DRAWING №4

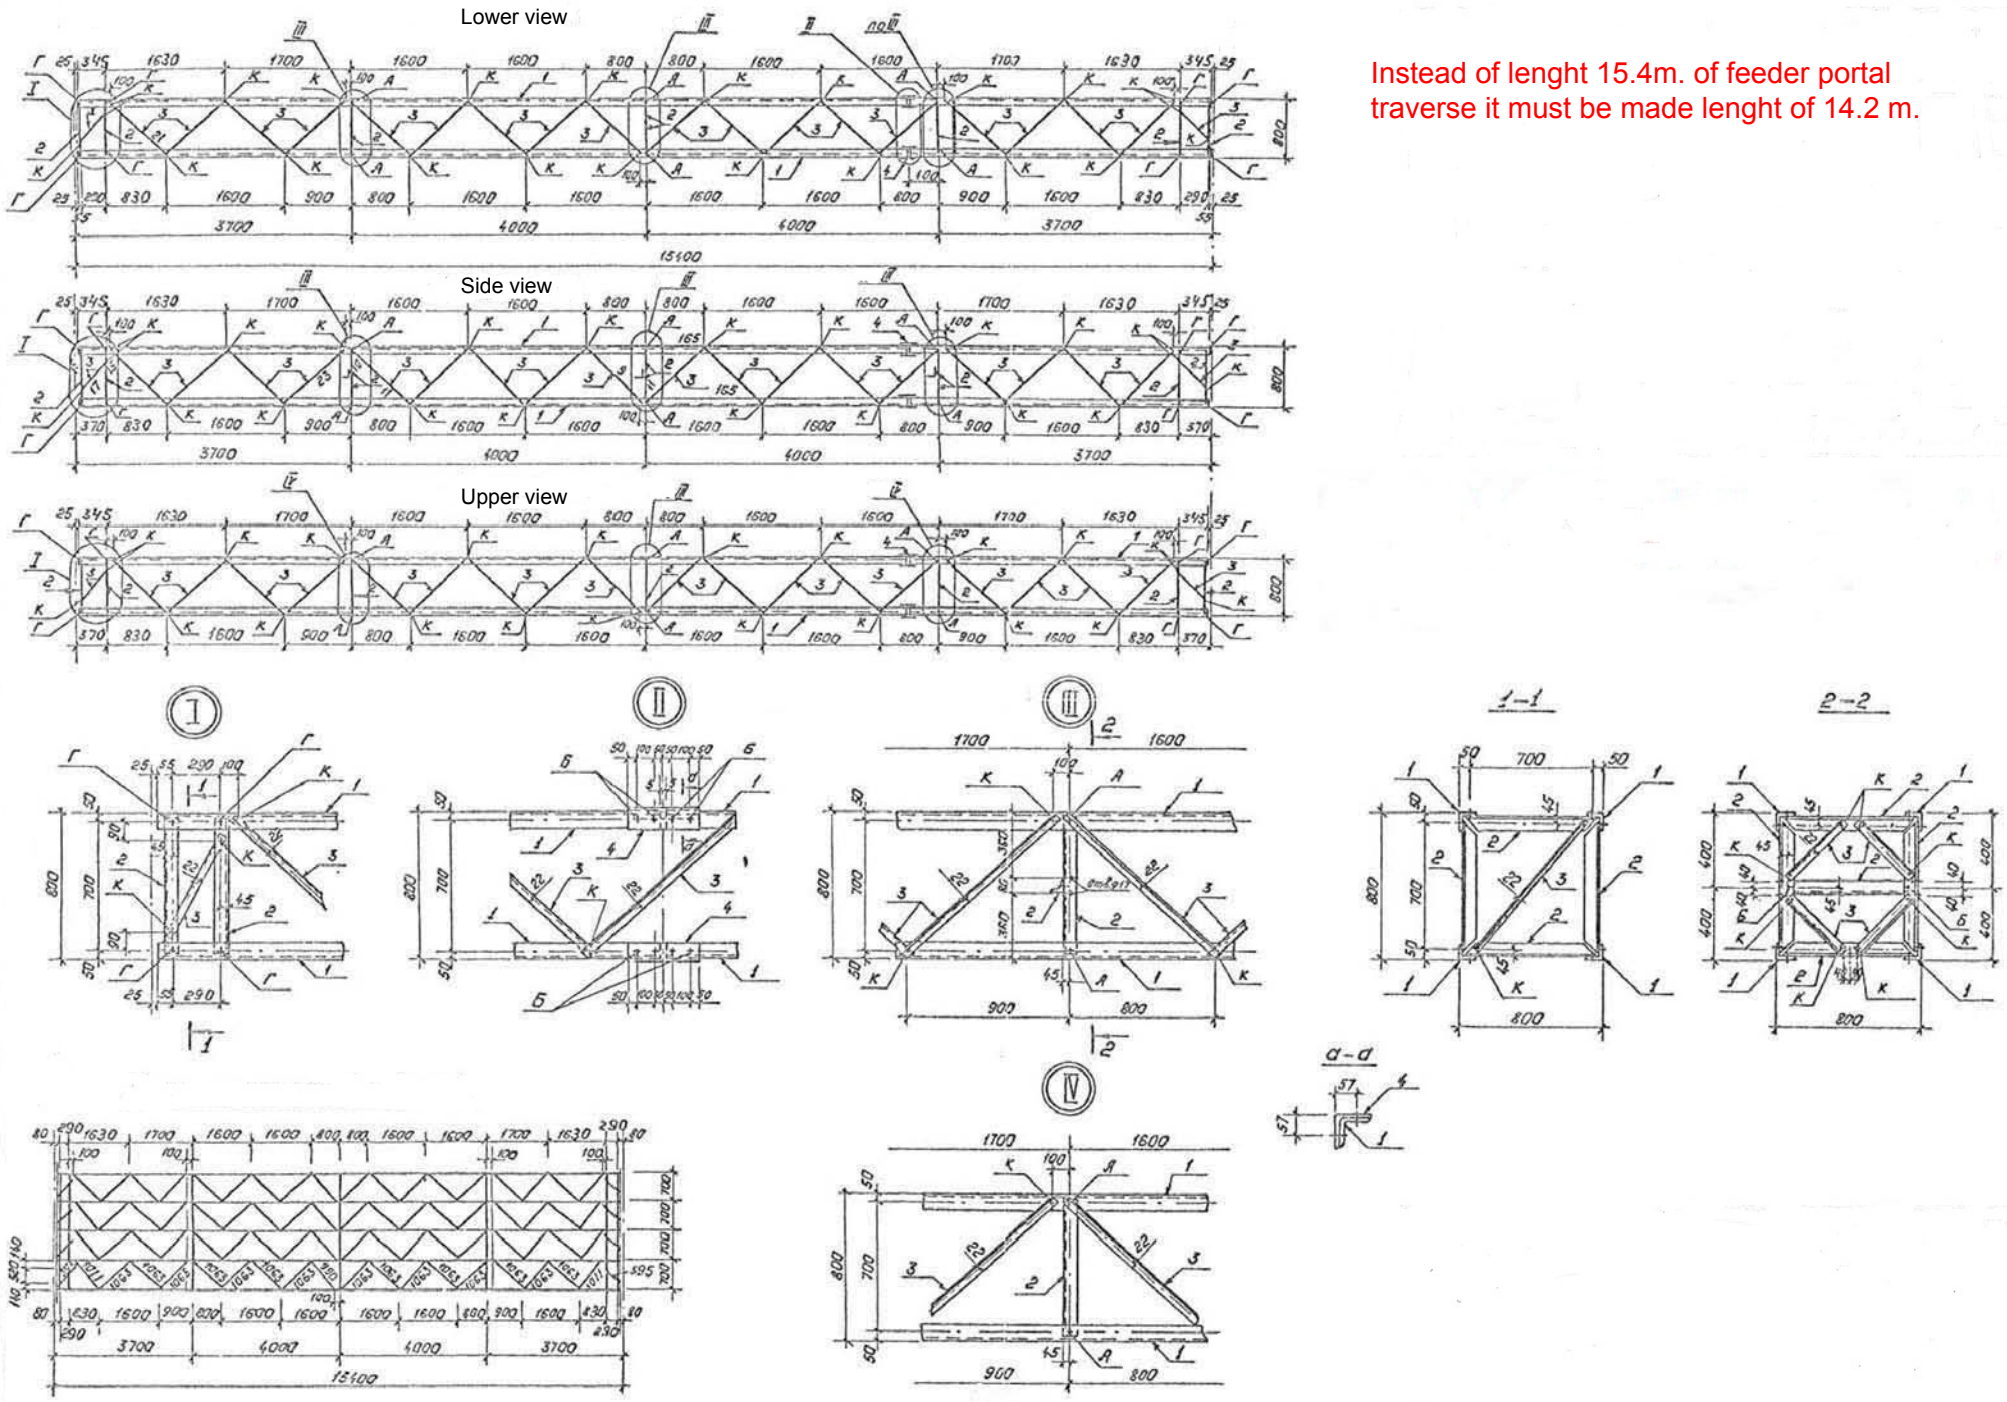
Instead of lenght 15.4m. of feeder portal traverse it must be made lenght of 14.2 m.

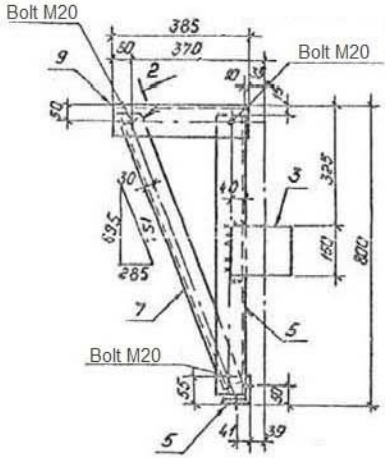
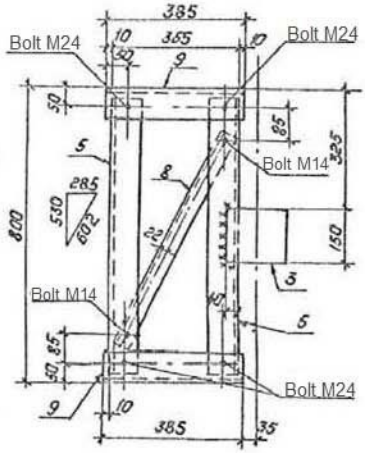
Pitting of traverse
